TECHNICAL SPECIFICATION CHANGE REQUEST TO ACHIEVE CONSISTENCY WITH SUBJECT:

A PREVIOUSLY APPROVED CHANGE AND CLARIFY AN EXISTING REQUIREMENT

Clinton Power Station, Unit No. 1 Re:

Amendment No. 17 License No. NPF-62

Figure 3.2.3-1. Clinton MCPR_{f} Versus Core Flow

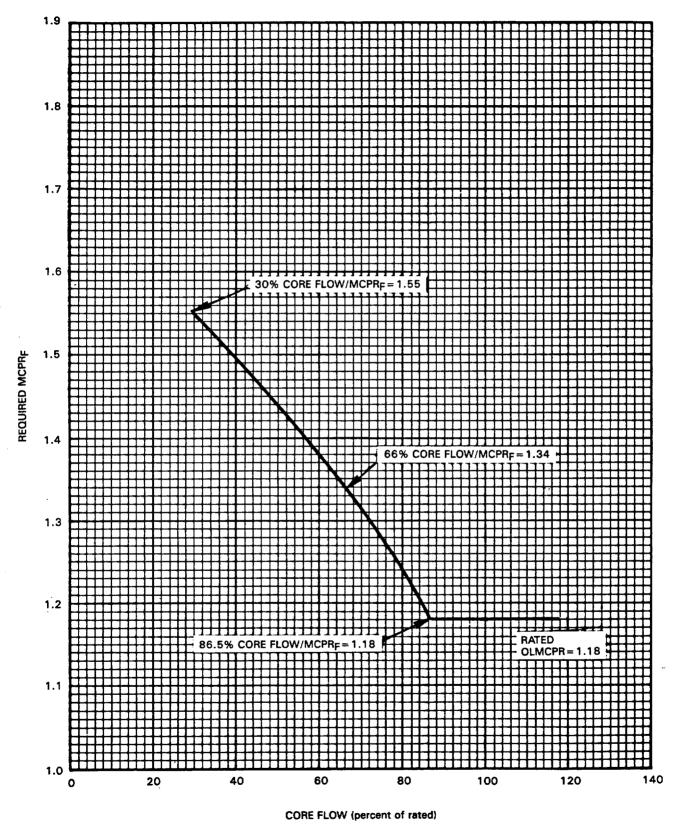
This amendment revises Technical Specification Figure 3.2.3-1 and Section 3.9.12 in order to clarify an existing requirement concerning the minimum critical power ratio as a function of core flow (MCPR_f) and to achieve consistency with the current wording contained in License Condition 2.D.(b) of the Full Power Operating License concerning the transfer of irradiated fuel from the reactor vessel.

The proposed change replaces Figure 3.2.3-1, "MCPR Versus Core Flow," to correct small graphical errors discovered on the original figure.

The original figure contains a plotted curve of the MCPR versus core flow and best-fit equations for the minimum critical power ratio as a function of core flow (MCPR). The values for MCPR obtained from the curve are slightly less than the values of MCPR obtained from the equations. G.E. was consulted by the licensees to develop a new curve which contains the exact Clinton specific values for MCPR as obtained from the equations. The differences in the MCPR values are insignificant in that the maximum difference between the new and old figure is 0.02 and at no time during operation did the actual MCPR approach the MCPR limit determined by either method. The proposed change does not involve any design changes, new requirements, or new modes of operation and is consistent with the accident analysis. The proposed change is considered acceptable.
